DEVIATION REQUEST AND DECISION FORM

Project Name : Winsome Filing No. 2

A deviation from the standards of or in Section **2.2.4.A.6** of the Engineering Criteria Manual (ECM) is requested.

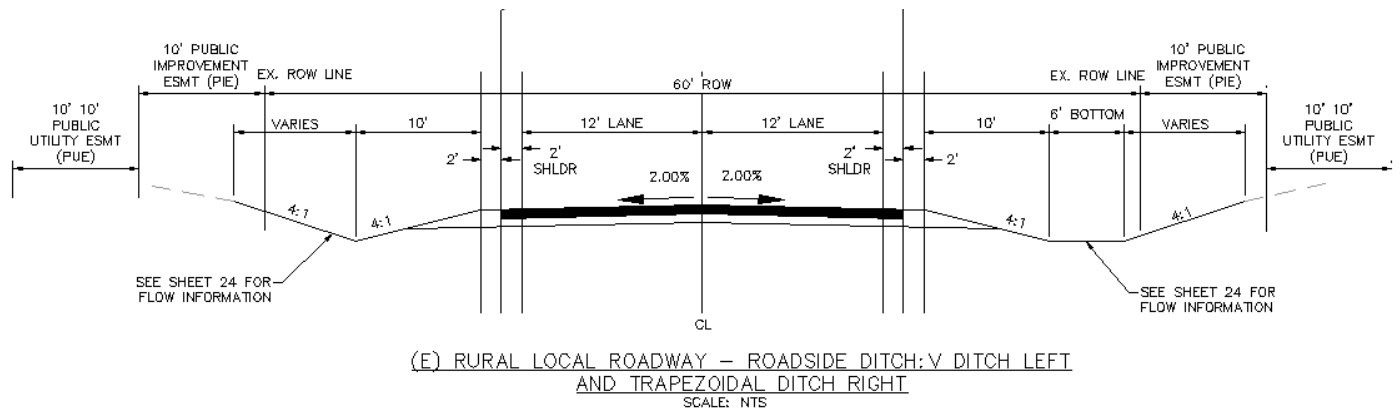
See ECM 2.5.8.C 2nd bullet point and update recommendations to provide the additional ROW.
